<b>PROJECT</b>
451 Addison Airport Tee Hangers

TEE-HANGAR DOORS  
TOP LATERAL SUPPORTS  
CITY OF ADDISON, TEXAS

We are pleased to submit this "BUDGET PROPOSAL" to you in regards to the proposed "T - Hanger" Door Guides per plans and specifications by Gunnin Consulting Engineers. Labeled Preliminary, dated 2/2/04 Sheet S-1, Located at the Addison Air Port.

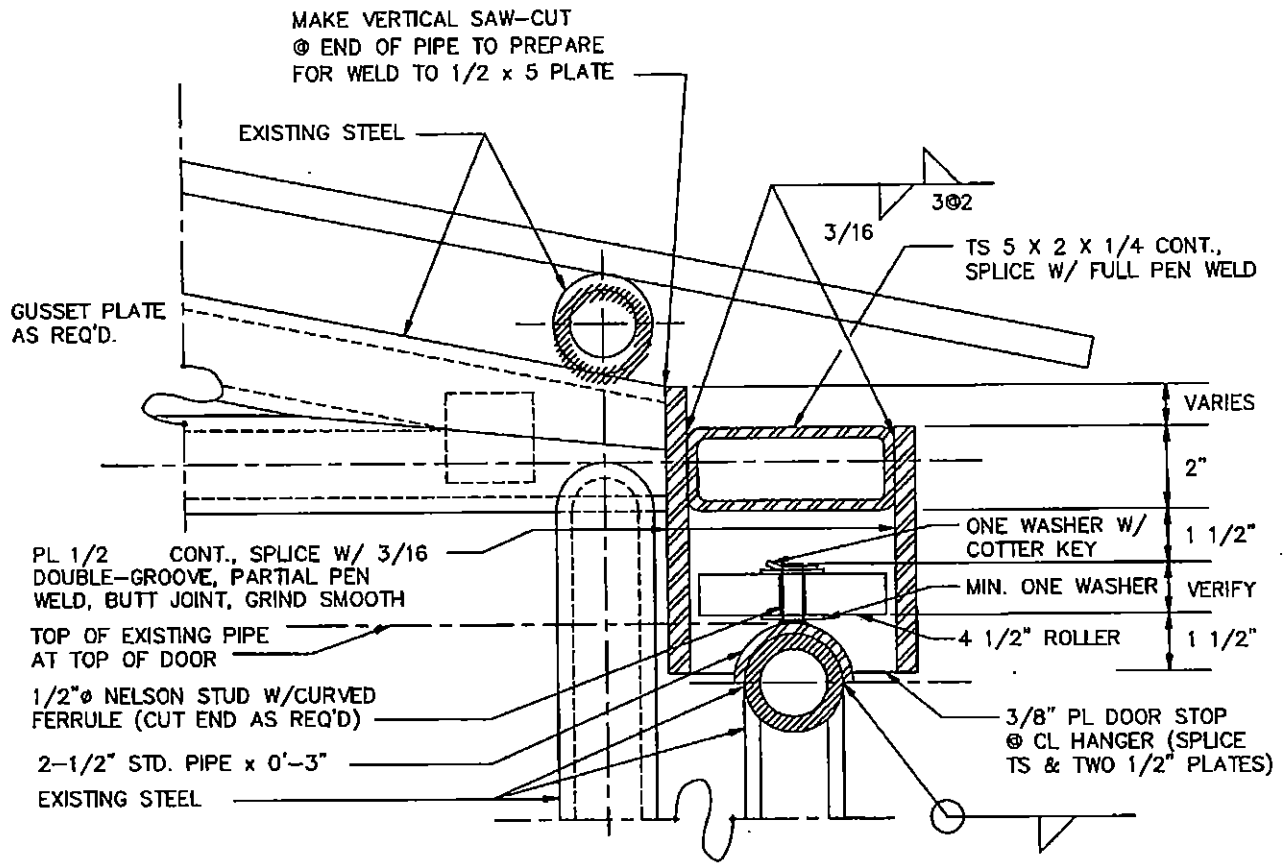
1. Add the following to the GENERAL NOTES:

9. CONTRACTOR SHALL SUBMIT SHOP DRAWINGS FOR STRUCTURAL STEEL AND REINFORCING STEEL, INCLUDING BOTH ERECTION PLANS AND MATERIAL LISTS. SHOP DRAWINGS SHALL NOT BE MADE BY USING REPRODUCTIONS OF CONTRACT DRAWINGS.

2. Revise the weld symbol of the fillet welds between the top of the TS and the two ½" plates from 3/16 – 3 @ 2 to 3/16 – 3 @ 12.
3. Add continuous 1/4" fillet welds between the bottom of the TS and the two ½" plates.
4. Add an arrow between the note "GUSSET PLATE AS REQUIRED" to the rectangular dashed box at the juncture of the sloped top chord of the rafter and the horizontal bottom chord of the rafter.

1 SECTION  
 SCALE: 3" = 1'-0"

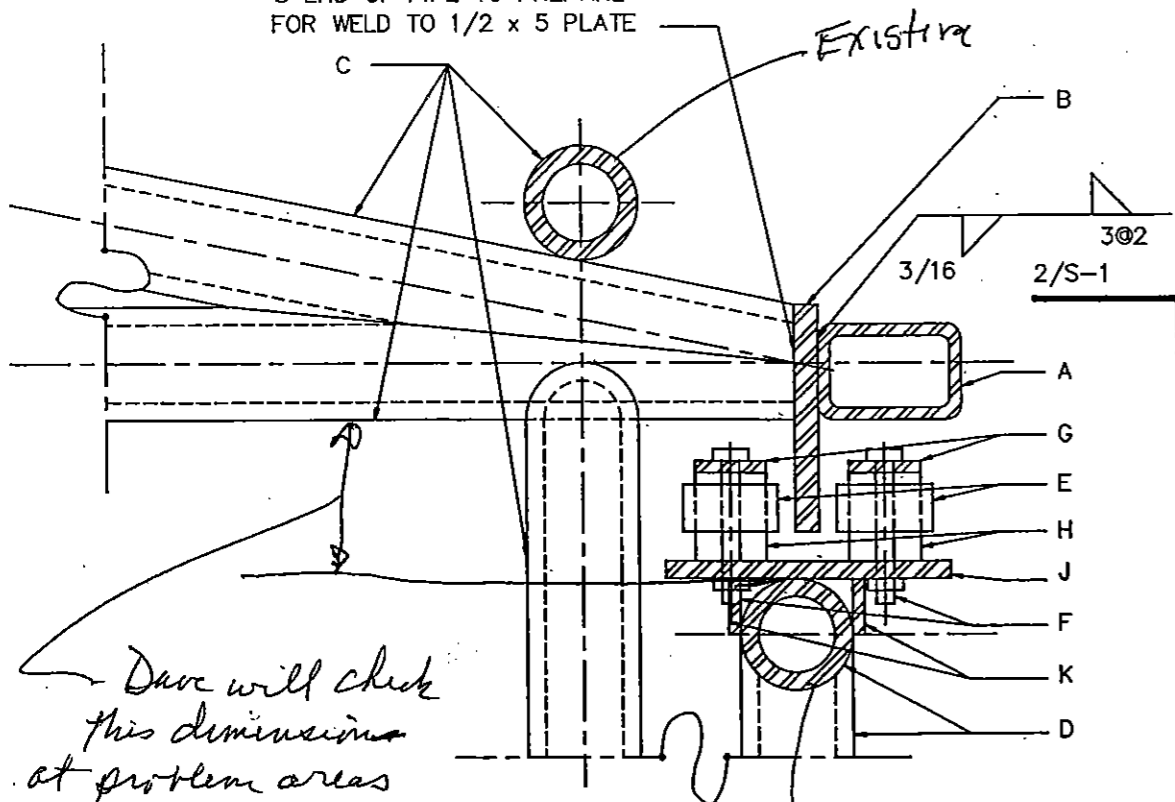
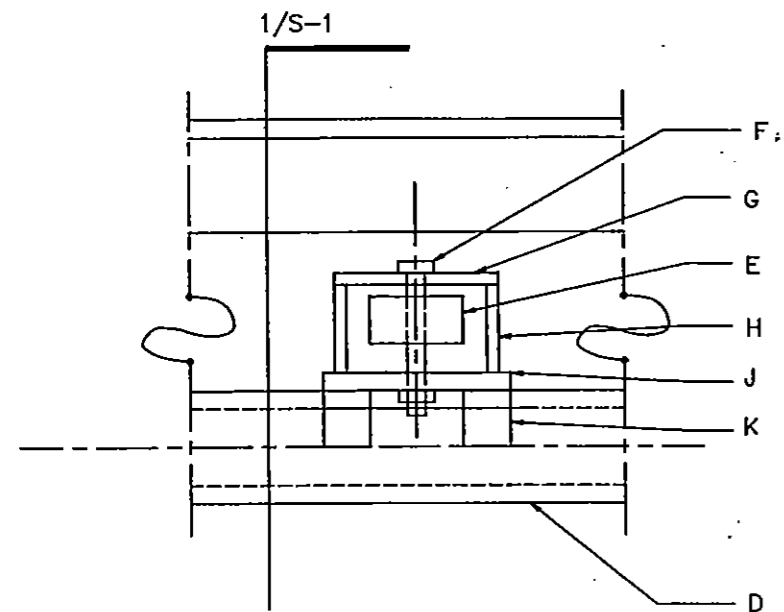
MAKE VERTICAL SAW-CUT  
 @ END OF PIPE TO PREPARE  
 FOR WELD TO 1/2 x 5 PLATE

PROPOSED FRITO LAY HANGAR  
FF=642.30

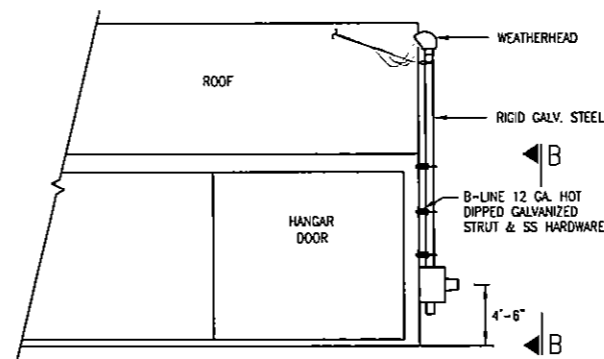
END 6" SANITARY SEWER @ A POINT 5' FROM BLDG FACE  
INSTALL:  
1-DOUBLE CLEANOUT  
FL 6"=838.80
